**MONACO PLACE
RENOVATIONS AND ADDITIONS
PROJECT NO. 0431**

**ADDENDUM NO. 2
PAGE 1
2009 -04-23**

Project: **1120 Ossington
Addendum No. 1
OUR FILE NO: 07007-00**

Mechanical Addendum No. 1

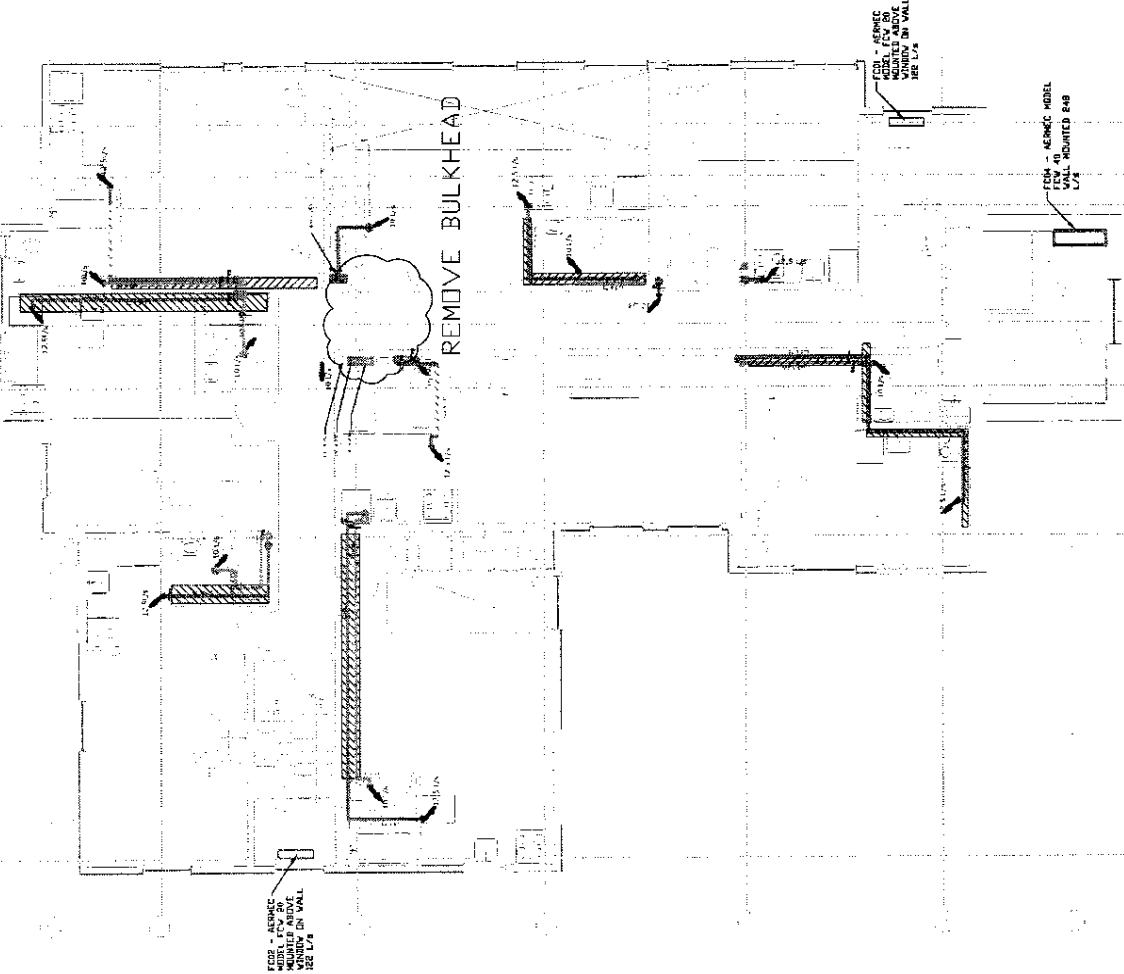
1.3 REFER TO DRAWINGS: DRAWING M09 AND M10, ROOF PLAN AND SCHEMATIC

- .1 Add drawings M09 and M10 to mechanical drawing set. Drawings M09 and M10 are attached. Refer to Appendix.
